Subject: Pre-Application Summary Notes for Hoy 9-Lot Subdivision (PA2018-0042)

Hoy 9-Lot Subdivision PA 2018-0042, July 25, 2018

Davies Road/Bluebell Lane Subdivision - Project Description:

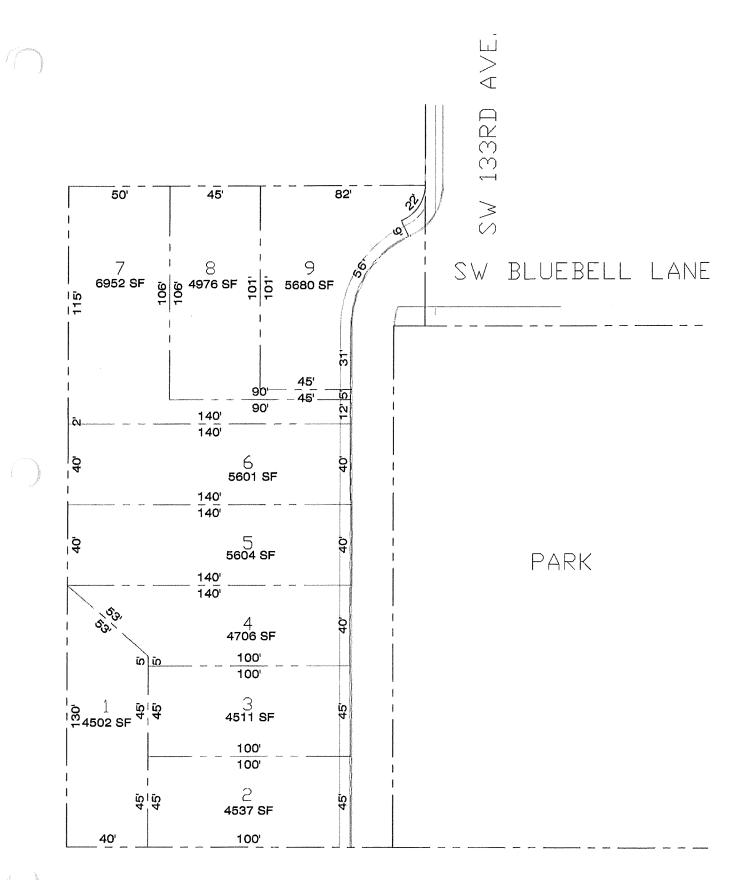
Please show documentation that you meet the 150' hose pull requirement for all structures.

A fire lane may be required for access to lots 7 and 8 if access is not provided within 150' of all portions of the structure. Disticnaces greater thatn 150' will be required to be marked as a fire lane.

Please provide documentation of fire flow for review.

Please indicate the location of fire hydrants.
